SUBJECT: **NEW VEHICLE DEMONSTRATION / DELIVERY HOLD**
Safety Recall 22S71 Supplement # 1
 Certain 2021-2022 Model Year F-150 Vehicles
 Windshield Wiper Motor Replacement

REF: **Safety Recall 22S71**
 Certain 2021-2022 Model Year F-150 Vehicles
 Windshield Wiper Motor Replacement

Safety Recall 22S71 **Supplement # 1**

FIGURE 1

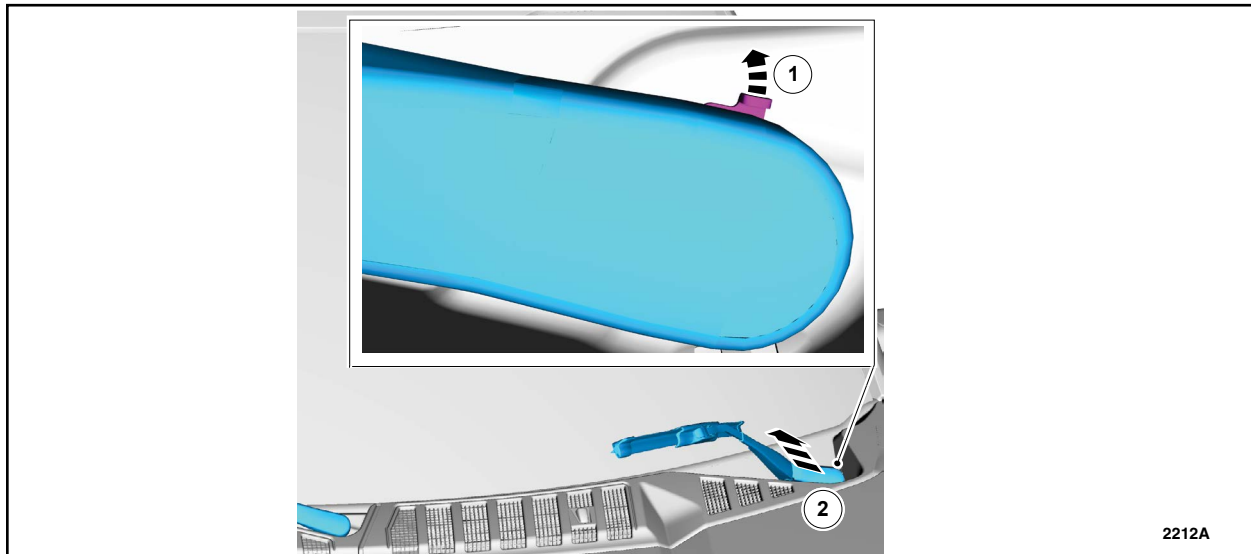
1. Remove the windshield wiper pivot arm. Left hand side only. See Figure 1.

FIGURE 2

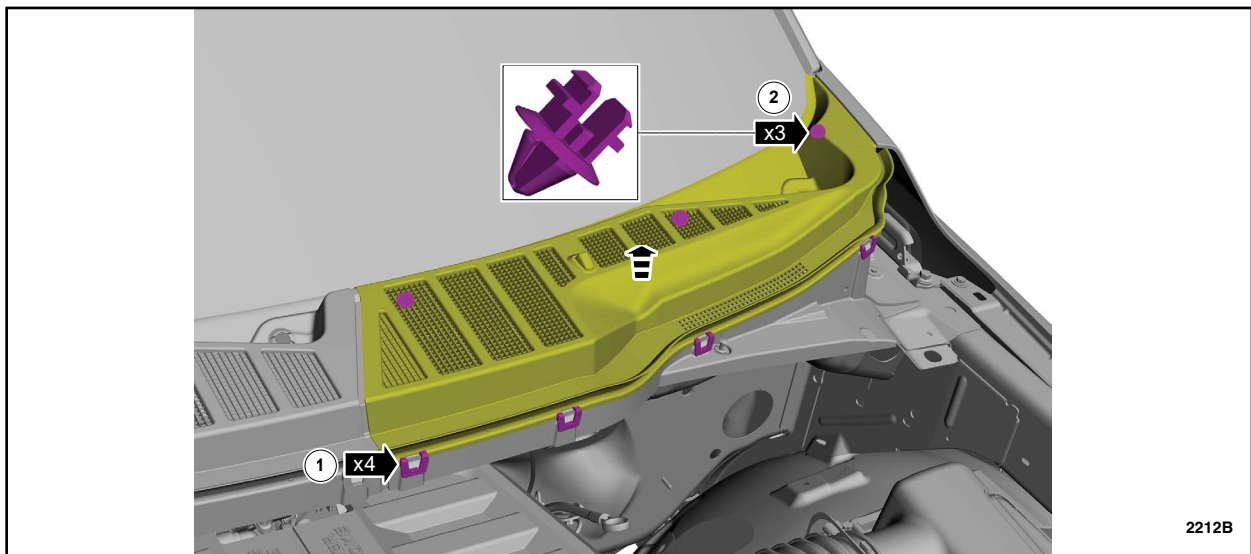
2. Remove the cowl panel grille. Left hand side only. See Figure 2.
